**TR-5599-4**

**ADDENDUM TO  
FINAL REPORT**

**INDEPENDENT DESIGN REVIEW  
SUSQUEHANNA STEAM ELECTRIC STATION**

**OCTOBER 27, 1982**

ISSUE 4.10

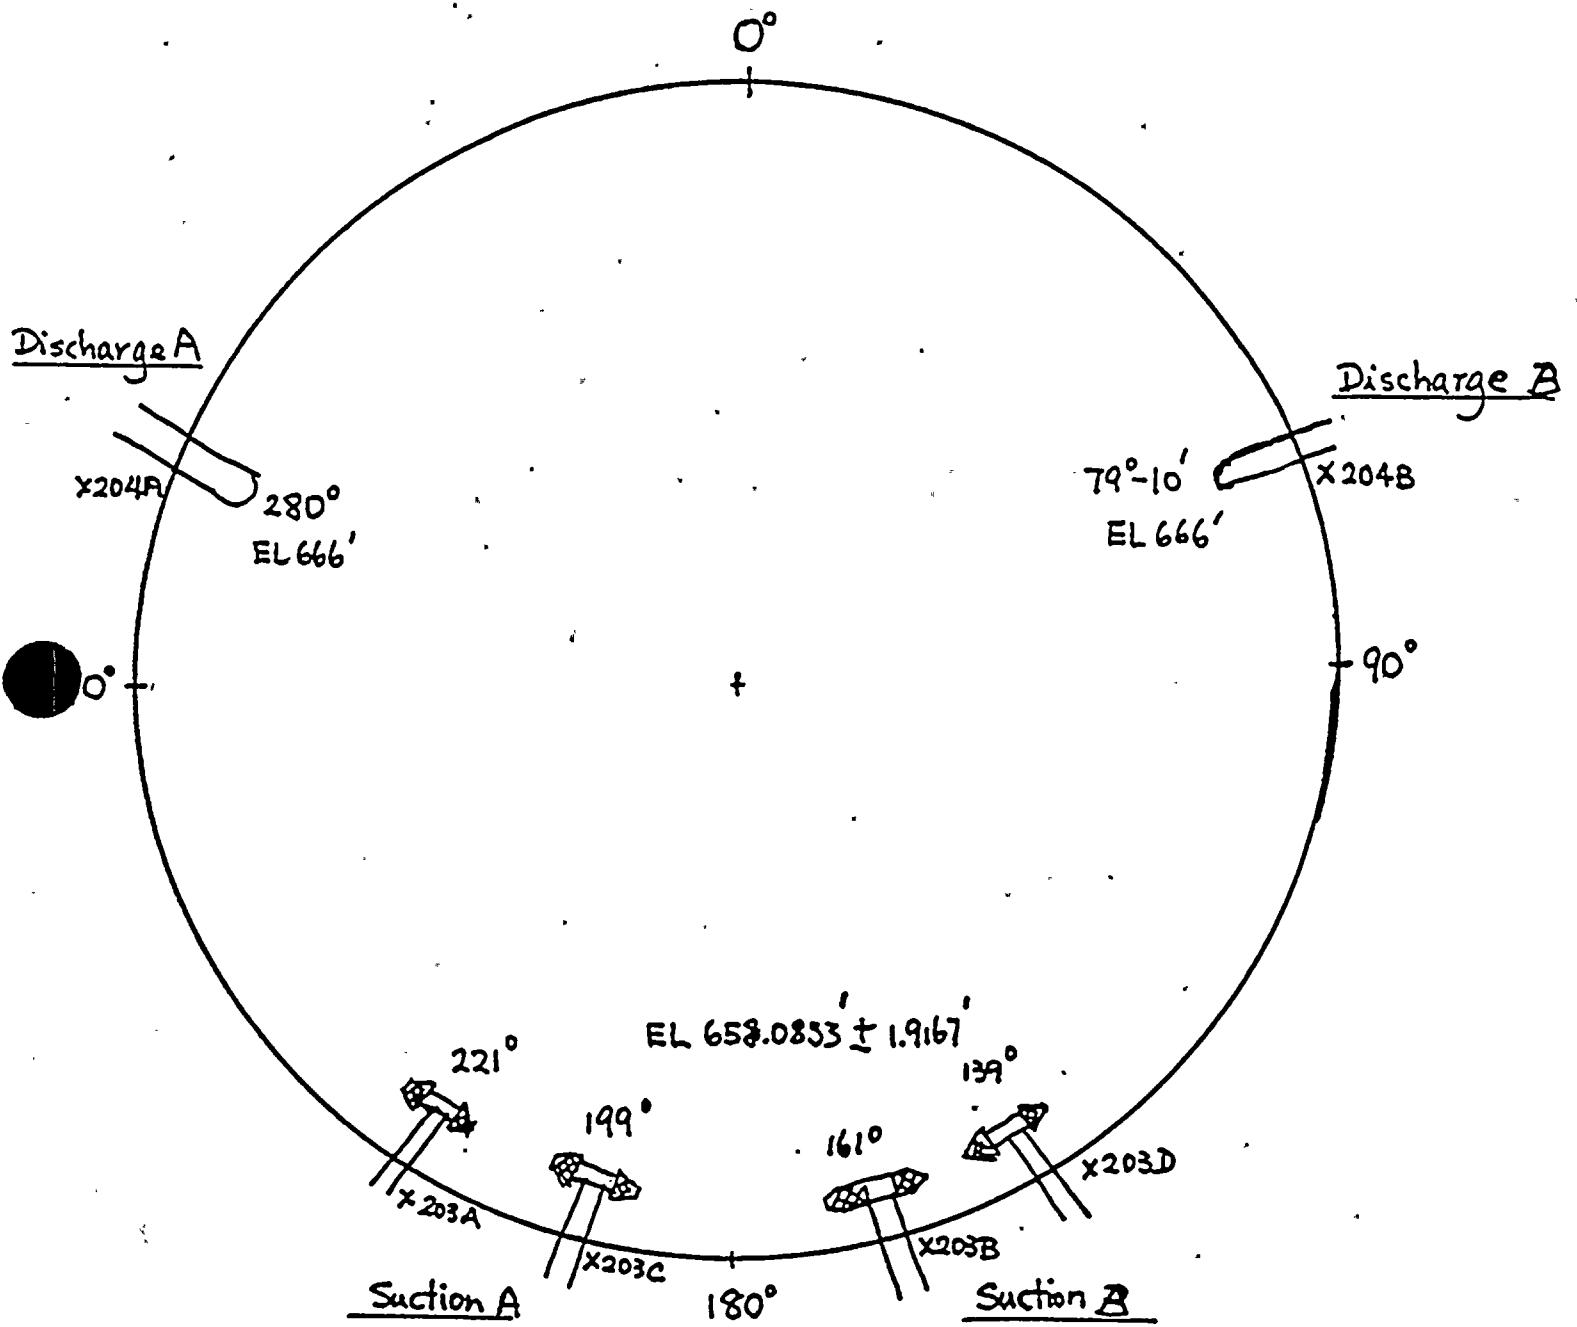
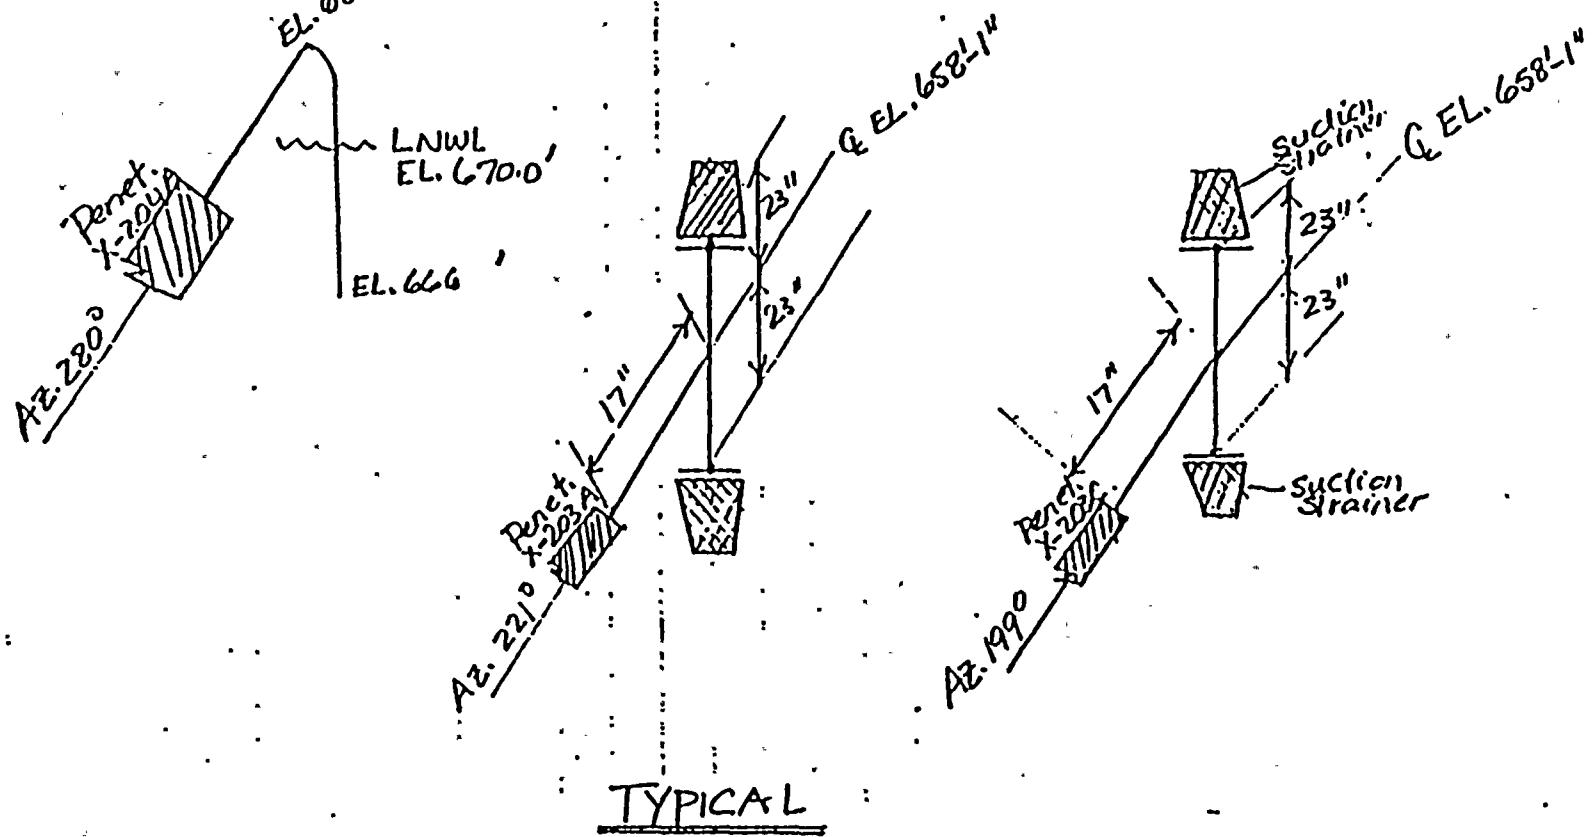
4.7 All analysis completed for the Mark III are generic in nature and do not consider plant specific interactions of the RHR suppression pool suction and discharge.

The sketch on the next page shows the relative positions of RHR suction and discharge. This configuration eliminates any concern with the discharge effluent short circuiting the pool and assures adequate pool mixing.

RHR Suction lines through penetrations X-203A & X-203C serve the discharge line through penetration X-204A.

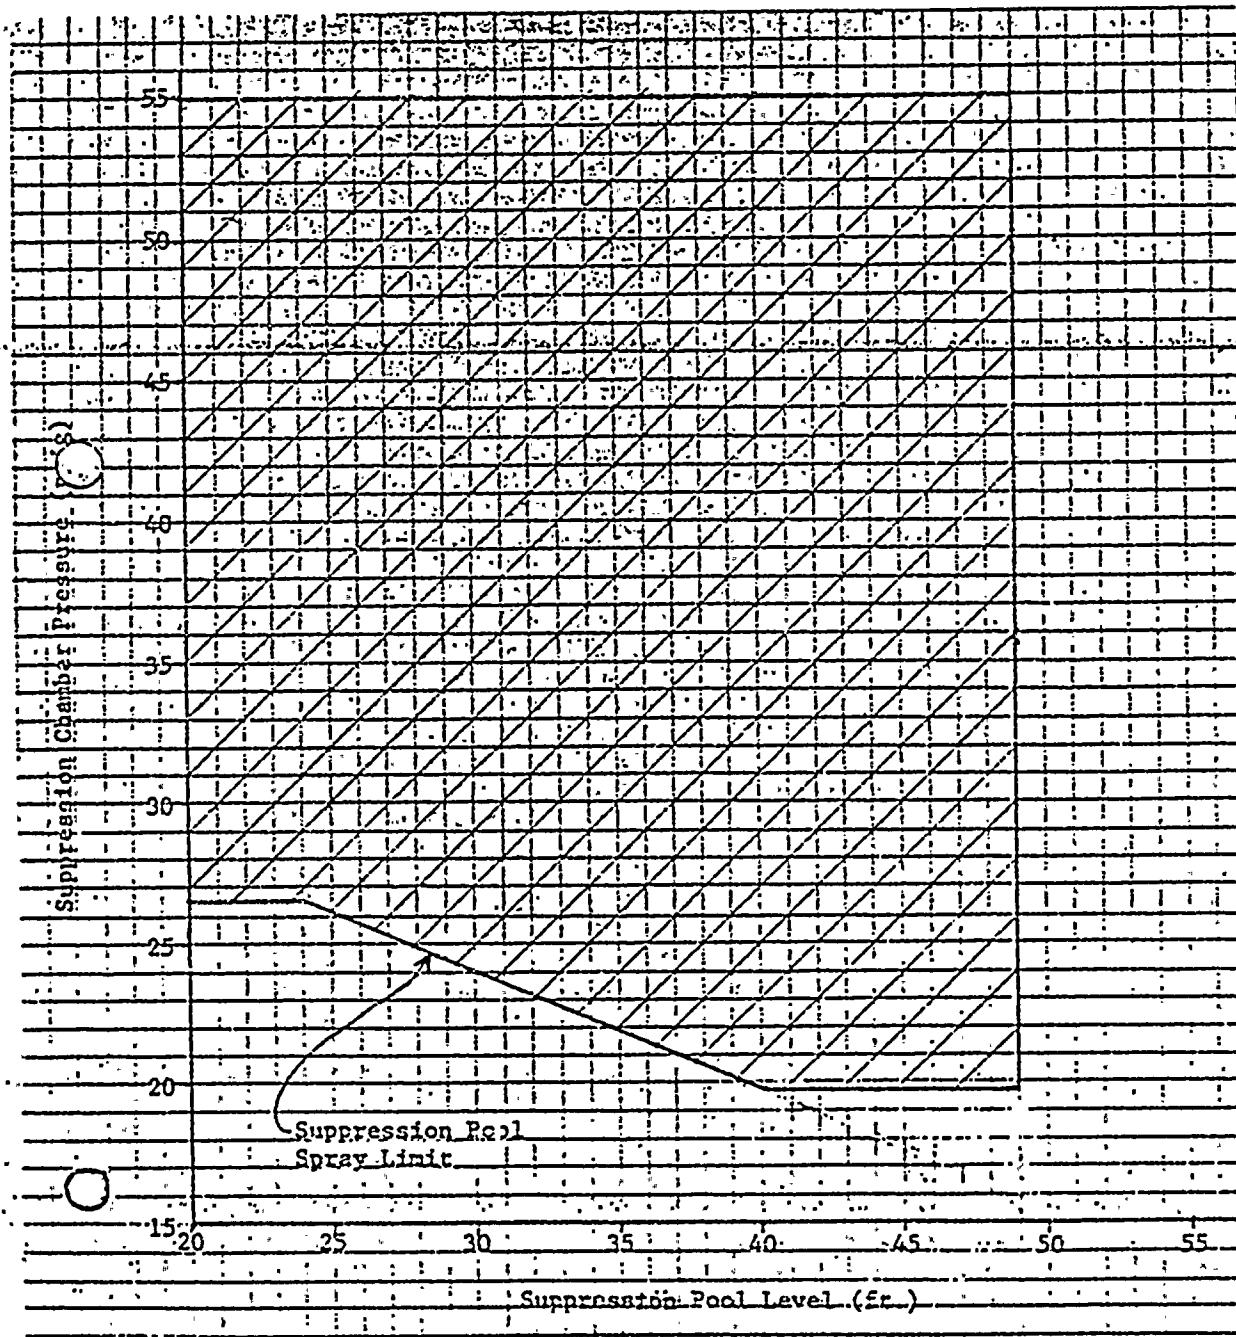
- 4.9 The effect on the long-term containment response and the operability of the spray system due to cycling the containment sprays on and off to maximize pool cooling needs to be addressed. Also provide and justify the criteria used by the operator for switching from the containment spray mode to pool cooling mode, and back again (pp. 147-148 of 5/27/82 transcript).

In addition, the procedure directs the operator to initiate suppression pool spray, if the suppression pool chamber pressure approaches the Suppression Pool Spray Limit (see figure next page). Furthermore, the procedure directs the operator to initiate drywell sprays, if the suppression chamber pressure approaches the Pressure Suppression Limit (see figure next page).

The Suppression Pool Spray Limit insures suppression pool spray before reaching 50% of the suppression chamber design pressure. The Pressure Suppression Limit insures drywell spray initiation before suppression chamber pressure indicates that pressure suppression has become ineffective.
